Pre-Submission Site Allocations

Schedule of Changes proposed in response to representations on the Focused Changes

January 2016

Schedule of Minor Changes to the Site Allocations Pre-Submission (incorporating Focused Changes)

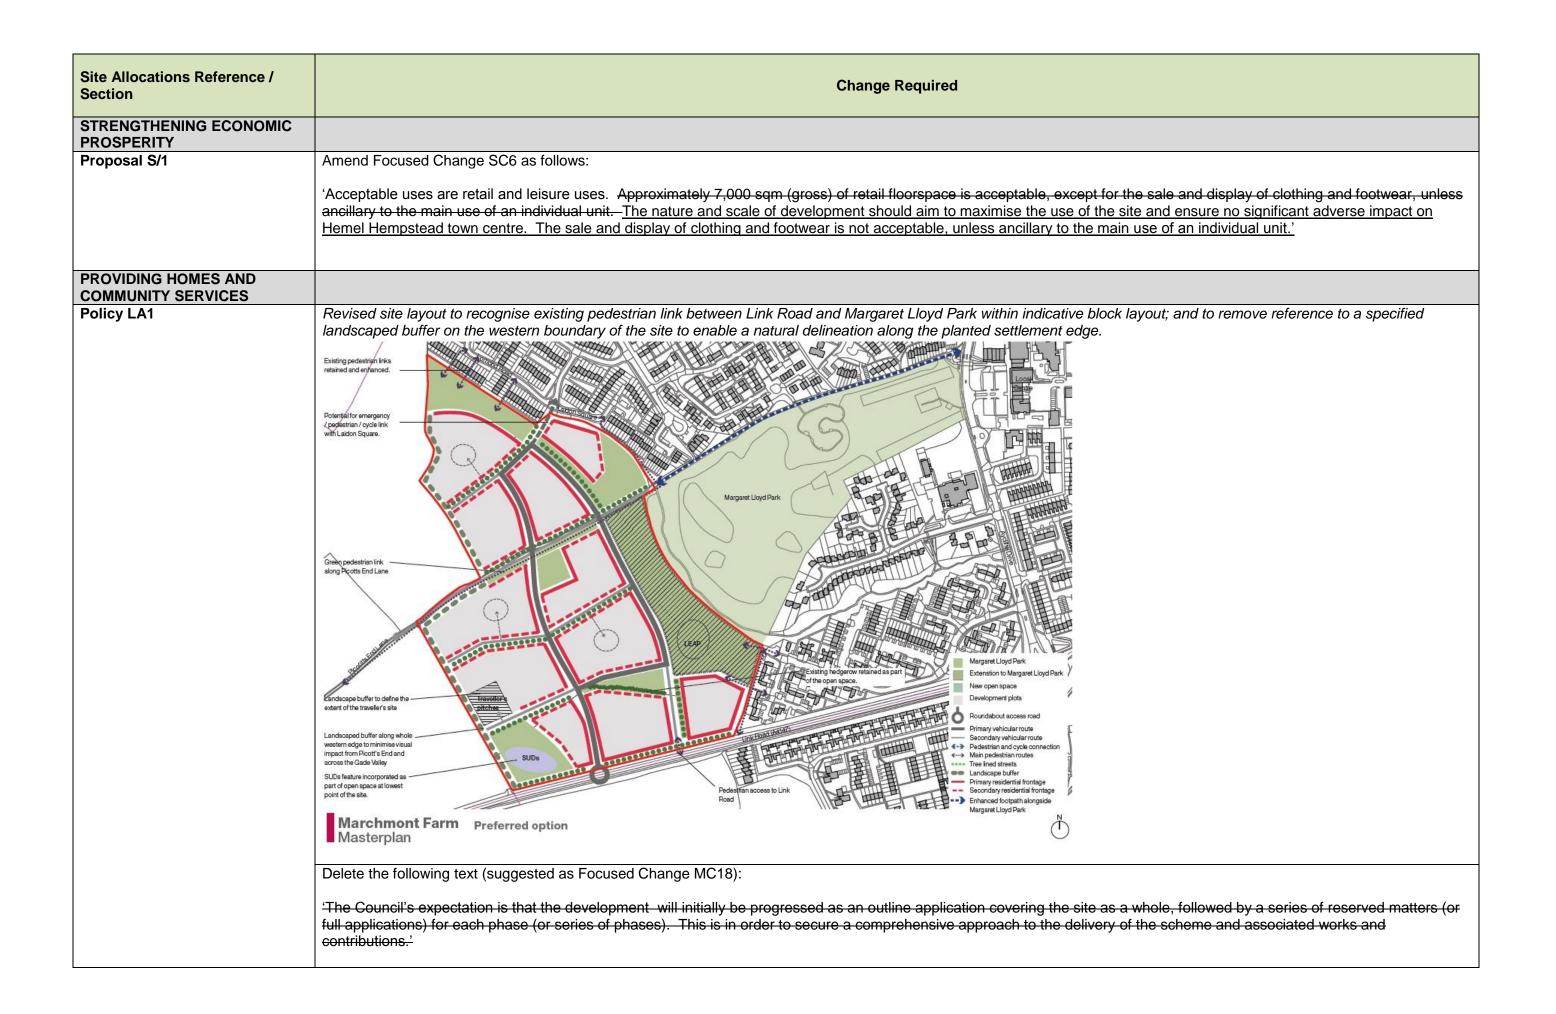
| Site Allocations Reference / Section | Change Required |
|--------------------------------------|--|
| Policy LA2 | Minor amendments to framework plan to make clear that there is no vehicular access linking with existing residential areas via Townsend). |

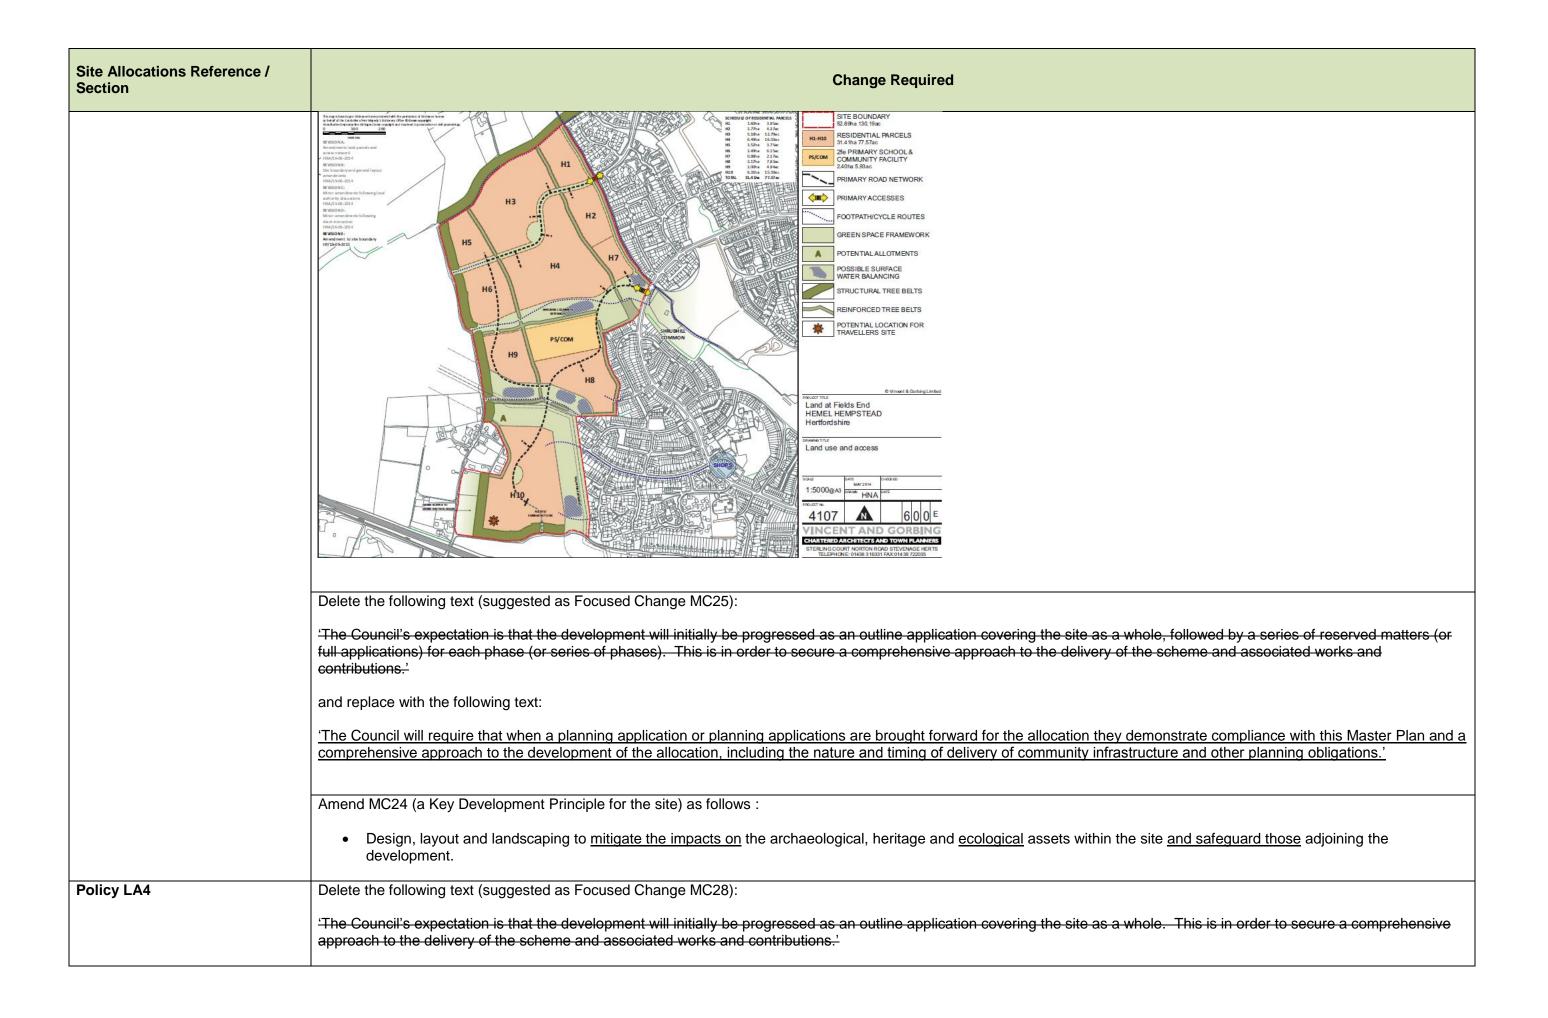
| Site Allocations Reference / Section | Change Required |
|--------------------------------------|--|
| Policy LA3 | Minor amendments to framework plan to remove reference to footpath access extending outside of the master plan area, to ensure consistency with the updated plan in the Master Plan document and to show correct extent of site in south west corner to tally with site boundary on Policies Map and master plan. |

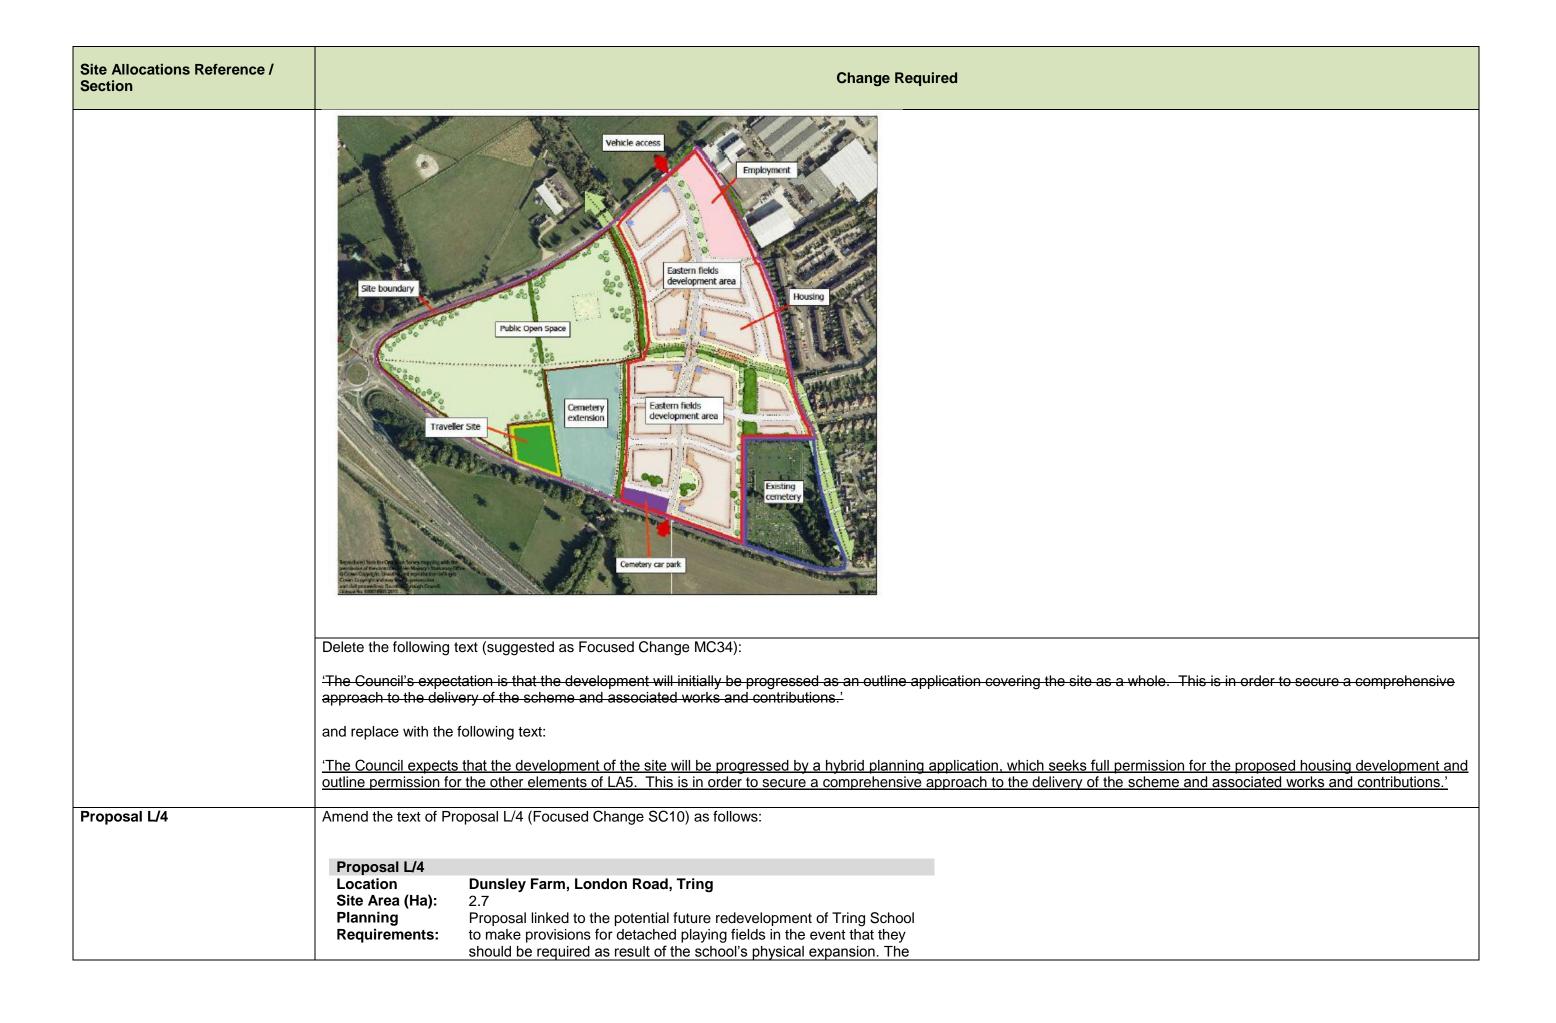
| Site Allocations Reference / Section | Change Required |
|--------------------------------------|--|
| | Replace existing indicative layout map with amended version below which deletes the words 'and other facilities' from the label for 'Cemetery car park', for consistency with changes made to the draft master plan. |
